Liddell battery and Bayswater Ancillary Works Project
Environmental Impact Statement

Response to submissions

July 2021

AGL Macquarie Pty Limited

Figure 3 - 1 EPL boundaries and updated consolidation of consents

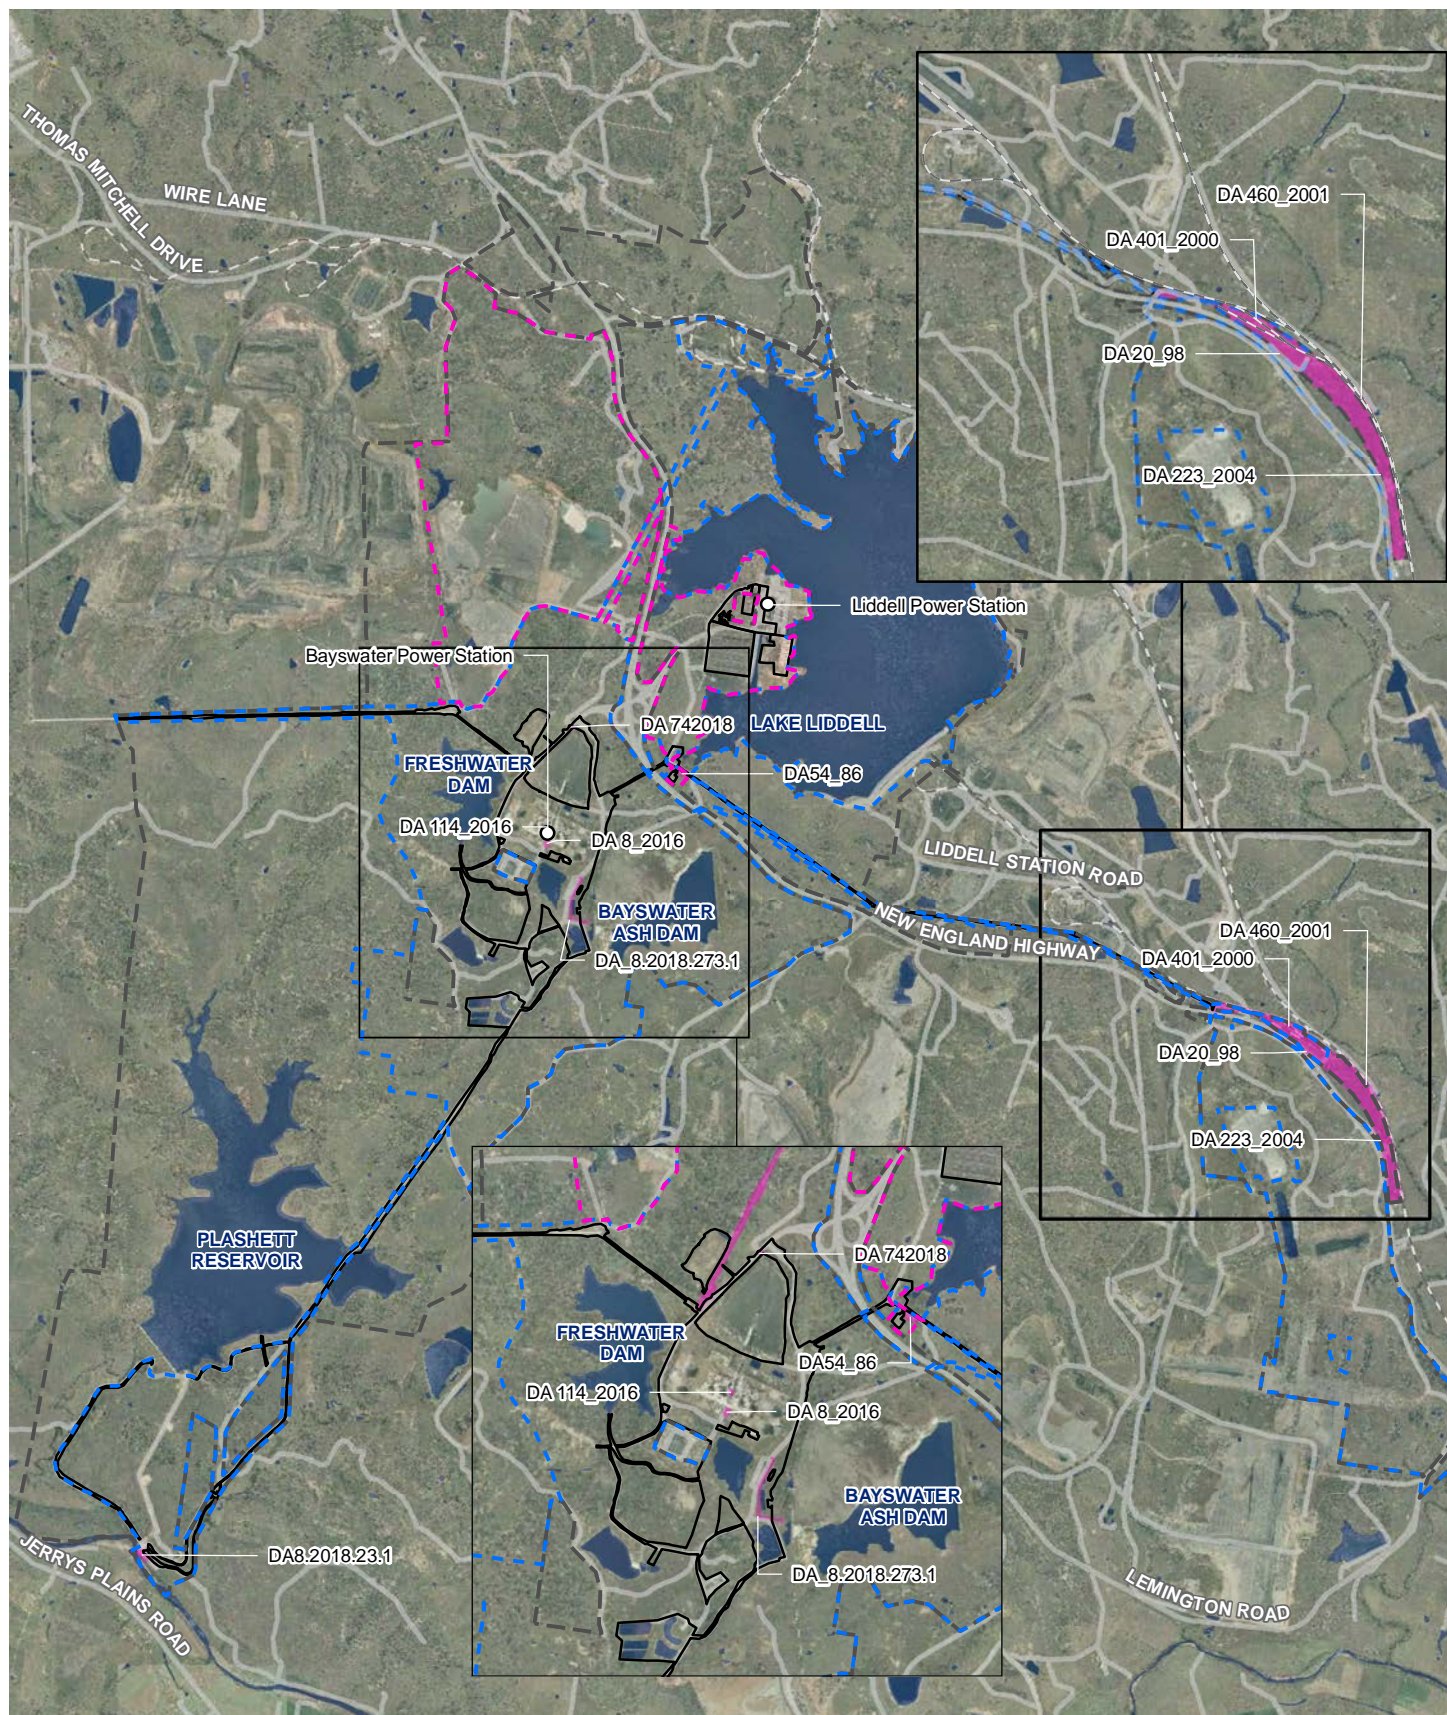
Recommendation / comment	Applicants Response
Consolidation of consents:	
MSC supports the consolidation of various approvals, from various dates, into a single approval	AGLM welcomes MSC's support in this regard. AGLM is committed to consolidating consents as indicated recently through the WOAOW and Liddell Battery and Decoupling SSD projects, refer to Section 3.2.1 .
Site disturbance, erosion and stormwater	
<ul style="list-style-type: none"> ▪ The assessment does not describe the extent of impacted areas, for example, if there are cuttings and batters, extra clearing, infrastructure relocations, supporting drainage structures and the like. ▪ Management of erosion and rehabilitation of disturbed areas will be a critical element of the Project. The Project needs to satisfy the following: <ul style="list-style-type: none"> - Limiting disturbance of development footprint to areas than can be reasonably managed in terms of batter slopes and extents - Avoiding large cut and fill on steep areas of the site - Avoiding clearing anywhere near established creek lines, and where existing vegetation is essential to maintaining slope stability - Capturing and appropriately detaining runoff from disturbed areas, prior to discharge to decrease sediment loss - Similarly capturing and appropriately detaining runoff from roofed structures - Stabilising and re-establishing disturbed areas in a timely manner in accordance with the Landcom Blue Book guidelines. ▪ The CoA should include a requirement for a comprehensive stormwater management plan for the battery compound that addresses how stormwater will be collected, conveyed, treated and safely managed. 	<p>Detailed design information is not available yet, however, as described in the EIS, all works would be limited to the assessed disturbance site and is likely to impact a much smaller area.</p> <p>Commitments are made in the EIS to the implementation of detailed stormwater, erosion control, sediment control, and rehabilitation measures. These would be documented in the Construction Environmental Management Plan (CEMP).</p> <p>Where possible, clearing near creek lines would be avoided. The BDAR (Appendix D) describes the areas where clearing is proposed.</p>

Further consultation and review of existing consents with DPIE, MSC and Singleton Council has resulted in an updated list of consents to be voluntarily surrendered and consolidated into the Project application if approved, refer to **Table 3-1** and **Figure 3-1**. DA 50-3-2005 Antiene Coal Unloader as shown as strikethrough text in **Table 3-1**, will no longer be included in the consolidation of consents on the basis that it is already regulated by DPIE.

Figure 4-1 Threatened species polygon for Striped Legless Lizard (*Delma impar*)

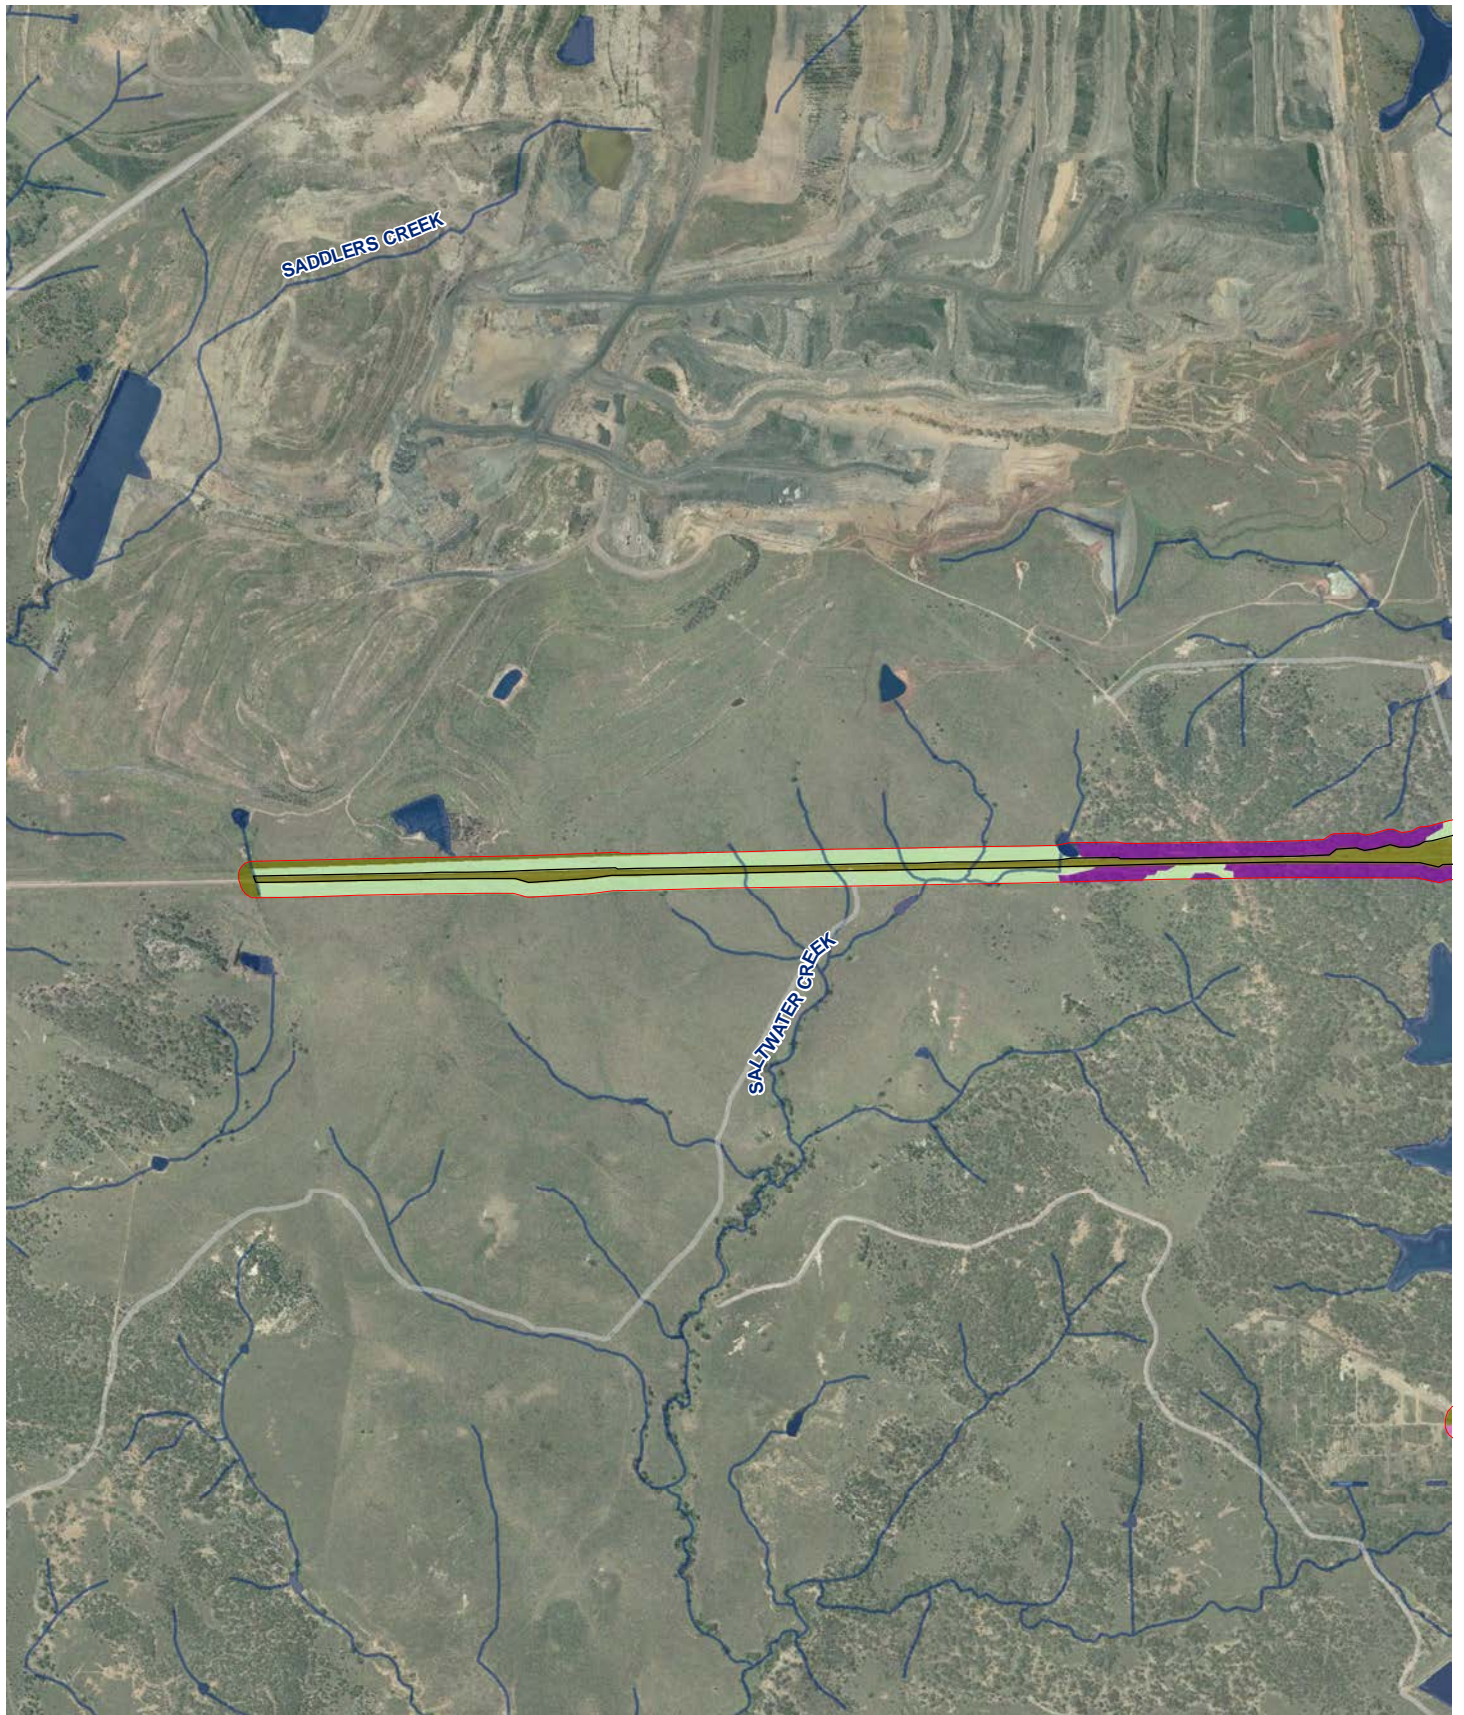
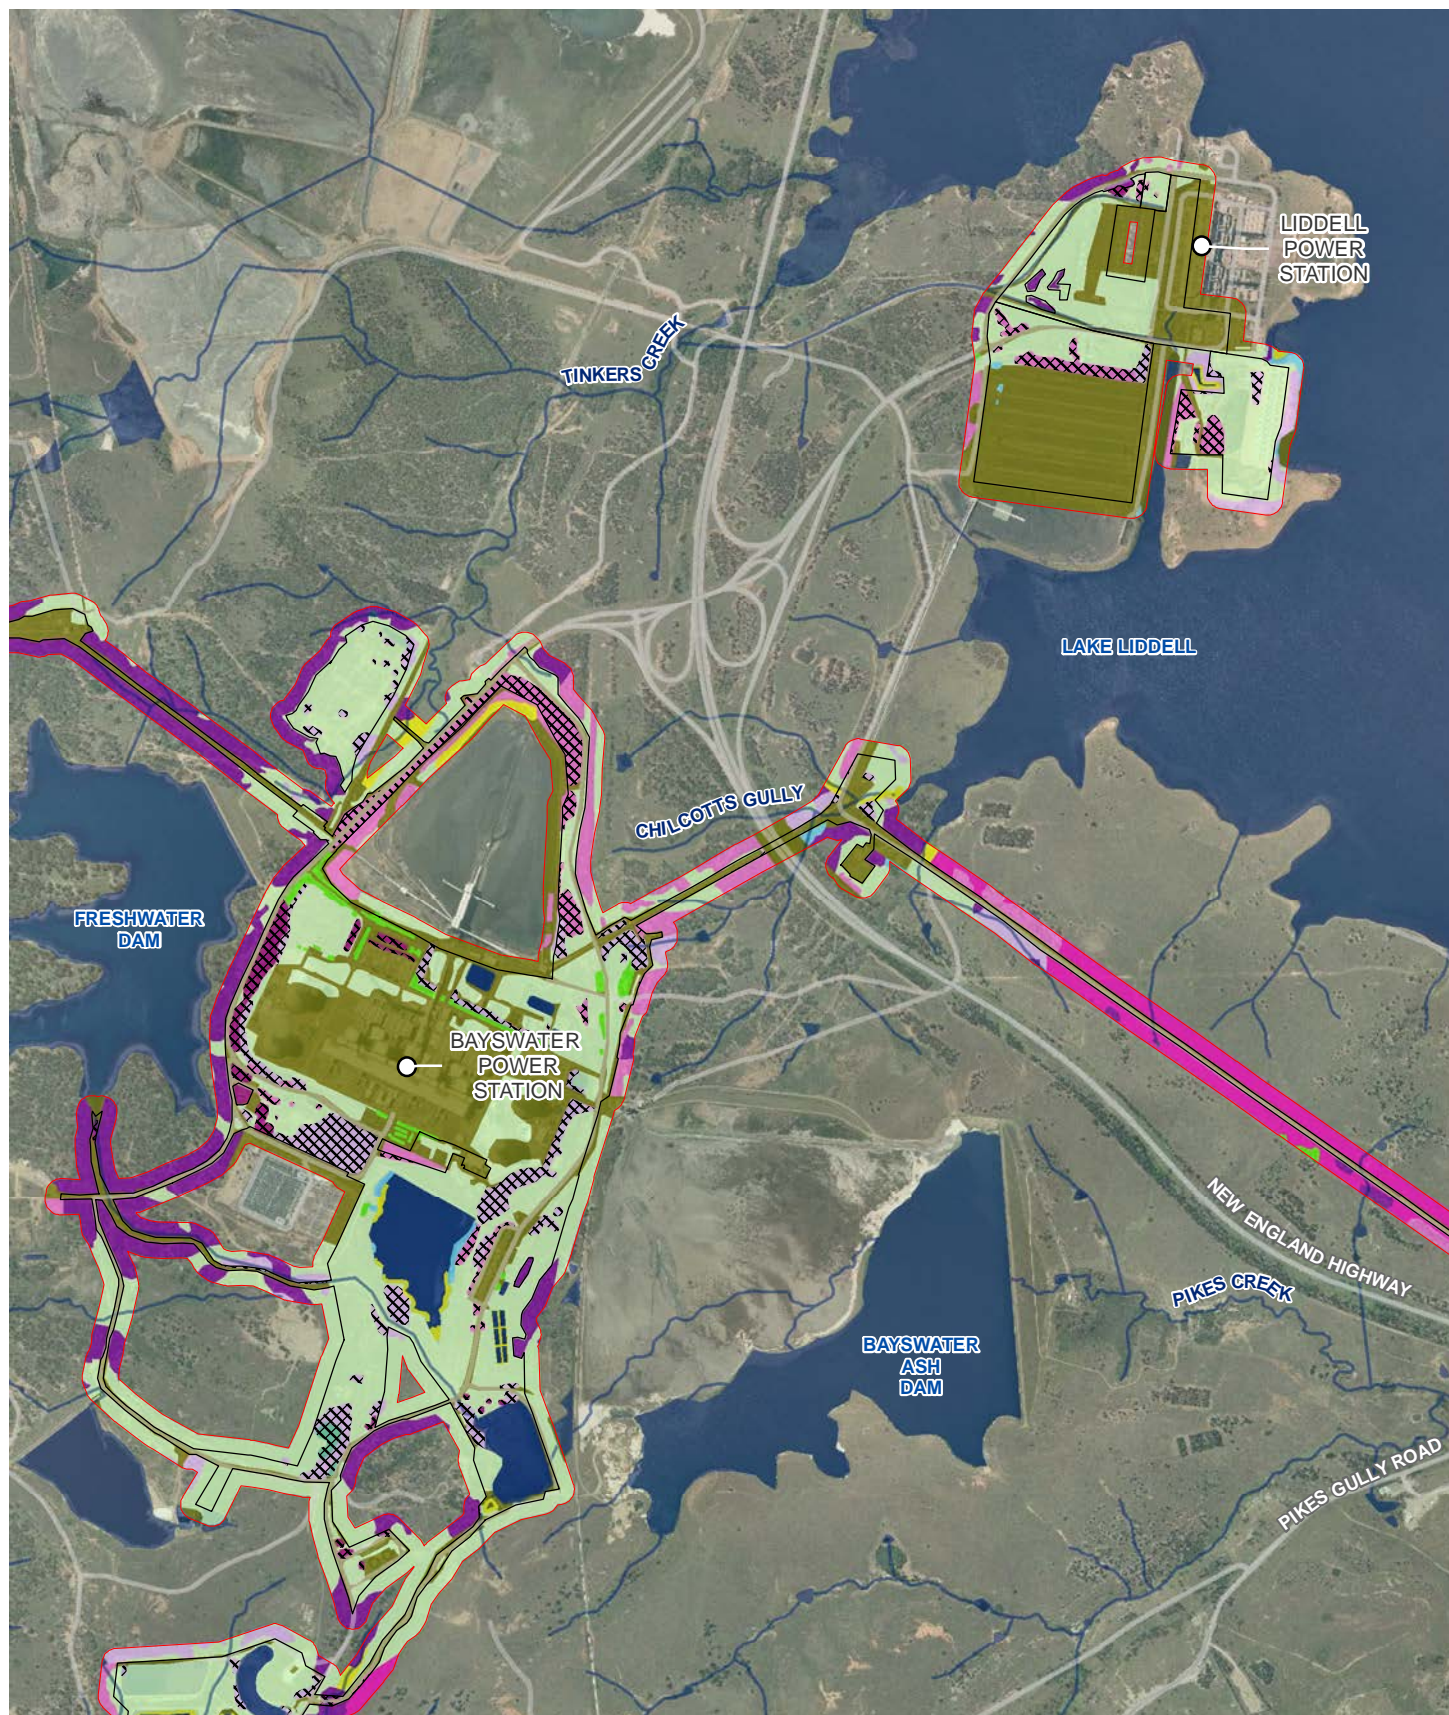
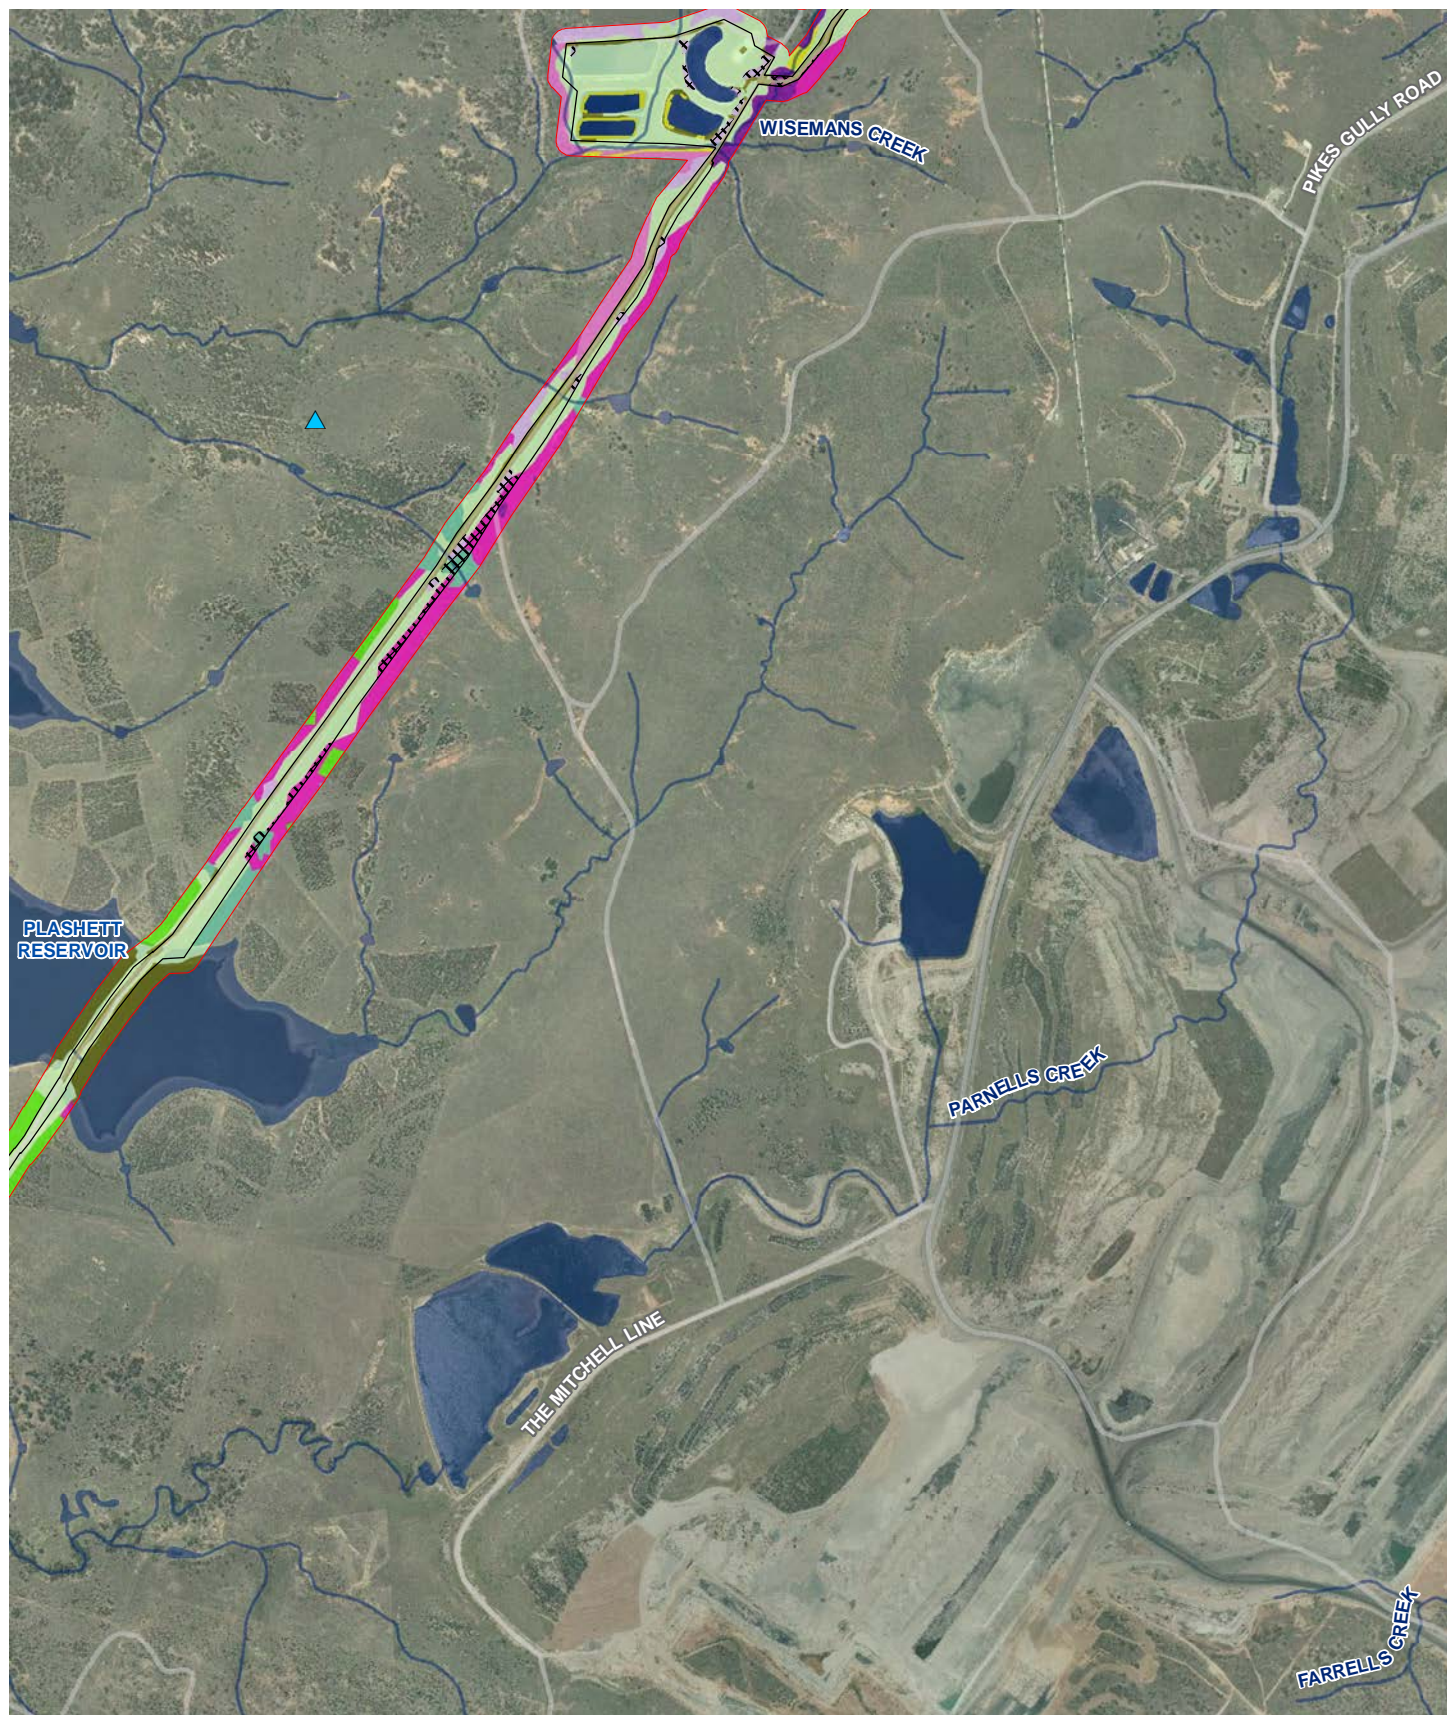
BCD Comment and recommendations	Applicant Response
Further justification should be provided for the exclusion of the Red Goshawk (<i>Erythrotriorchis radiatus</i>) from further assessment	The BDAR has been updated with further details on the Red Goshawk (<i>Erythrotriorchis radiatus</i>). The Red Goshawk has now been added to the BAM-C Candidate species list, refer to Section 4.3.2.2 .
A new version of Figure 6-1 'Threatened flora surveys' is prepared, at 1:1,000 scale, that clearly shows the location of targeted flora surveys, and the vegetation zones in which they were conducted	New figures have been prepared for the revised BDAR, refer to Appendix D . A 1:1000 scale figure would require about 150 pages. As such 1:1000 scale figure has not been generated. The figures have been updated so that they do provide clearer illustration of survey effort and vegetation zones. Geographic Information System (GIS) data has also been provided to BCD for their reference.

The habitat for the Striped Legless Lizard within the development site is considered to be low-quality given that much of the land was cleared for cattle grazing in the past and has been modified to accommodate power station infrastructure. Areas of native vegetation still exist as small and isolated patches and may provide potential habitat for this species, refer to **Figure 4-1**. The PCTs associated with the Striped Legless Lizard include:

As outlined above, the Striped Legless Lizard is known to inhabit the higher-quality woodland habitats to the west of the development site. As such this species could potentially disperse eastward across the development site on occasion, although habitats within this area are already isolated by significant infestations of exotic grasses, coupled with movement barriers such as roads, water canals and power station infrastructure. The ground surfaces of the development site have historically been modified and generally lack shelter features such as rocks, logs, wood debris and native tussock grasses. Future detailed design would further retain vegetation within the development site and the Project is unlikely to exacerbate barriers to dispersal for the Striped Legless Lizard.
